# HISTORIC AND DESIGN REVIEW COMMISSION

May 17, 2017

**HDRC CASE NO:** 2017-180  
**COMMON NAME:** 421-425 E MISTLETOE  
**LEGAL DESCRIPTION:** NCB 863 BLK LOT 14 E 45.5 FT OF 13 & W 4.5 FT OF 15  
**ZONING:** RM-4  
**CITY COUNCIL DIST.:** 1  
**APPLICANT:** Ricardo Turrubiates/Tarramark Urban Homes  
**OWNER:** K/T TX Holdings, LLC  
**TYPE OF WORK:** Construction of housing development

FRONT ELEVATION

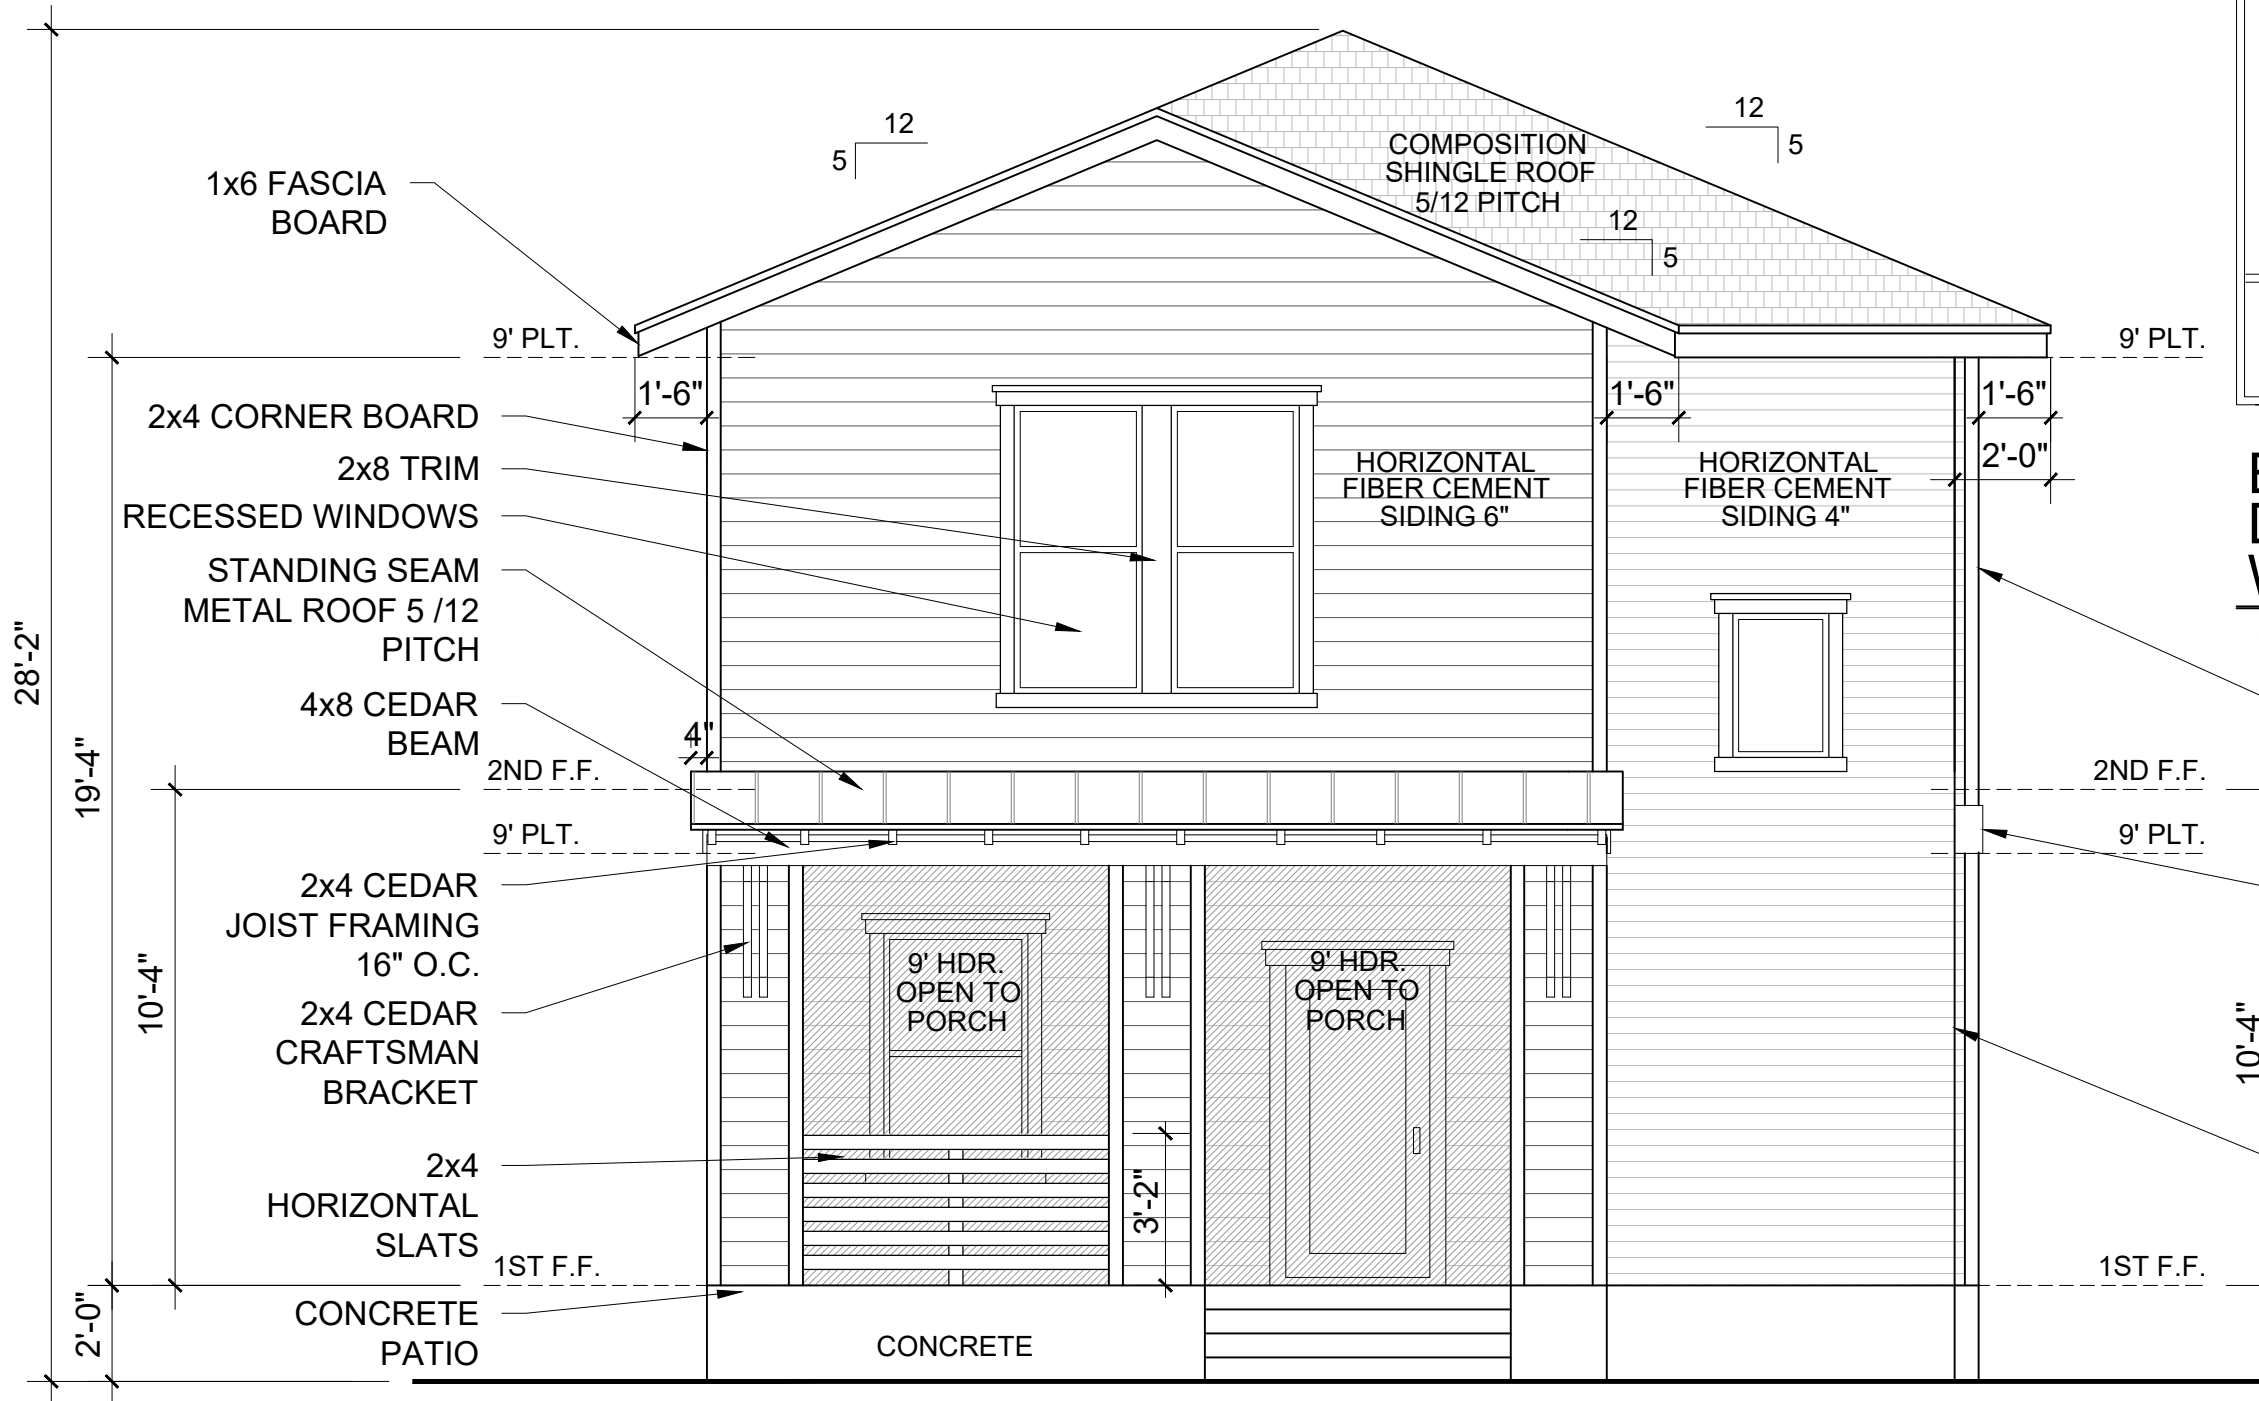
- e. **MASSING AND SCALE** – The proposed Building 1 and Building 2 measure approximately 20'-6" in height without including the roof pitch. Prototype 1436 measures 28'-2" to the top of the roof ridgeline. While the proposed Tobin Hill North Historic District contains nine two-story single family homes, the rest of the block of E Mistletoe surrounding the proposed development contains single-story single family homes. Guideline 2.A.i stipulates that the height and scale of new construction should be consistent with nearby historic buildings and should not exceed that of the majority of historic buildings by more than one-story. Staff finds the proposed height inconsistent with this guideline.

- l. PROTOTYPE 1436 – This design will be one of two homes fronting the E Mistletoe streetscape, located at the southwest corner of the lot, as indicated in the submitted site plan. The 2-story house features a composition shingle hipped roof with a low-pitched front gable, a standing seam metal roof projecting from the first story approximately 2’-7 ½” inches to cover the entryway porch, and 2x4 cedar joist framing in a Craftsman bracket style beneath. The wall material is horizontal fiber siding cement with a 6” profile on a majority of the structure, with horizontal fiber cement in a 4” profile covering the inset on the southeast corner. The foundation is 2’ concrete with concrete steps. The total height of the structure is 28’-2” at the highest point of the roof ridge line. Guideline 2.A.i stipulates that the height and scale of new construction should be consistent with nearby historic buildings and should not exceed that of the majority of historic buildings by more than one-story. Staff finds the proposed height inconsistent with this guideline. Additionally, the square windows on the second story of the left elevation are inconsistent with the Historic Design Guidelines, OHP Window Policy document, and historic fenestration pattern of the proposed district. The Historic Design Guidelines also note that new architectural details should be reflective of their time while respecting the predominant stylistic elements of the district. Staff finds the proposed front elevation overhang inconsistent with street-facing porches of the district.

- a. The applicant explores designs that respond to the context of the district versus utilizing designs that are built or proposed in other parts of the city.
- b. The applicant explores 1.5 story options or prototypes with a modified roof pitch to respond to the dominant historic massing context of the neighborhood.
- c. Fenestration patterns on all prototypes are revised to be more consistent with the size and placement common of historic facades in the district.
- d. That the front porch configuration for Prototype 1436 is modified to include two columns that project from the façade and engage the streetscape.
- e. That the proposed windows are true divided lites or a 1 over 1 configuration with wood screens featuring divided lites to reflect window configurations common in the district and the proposed modern Craftsman approach.
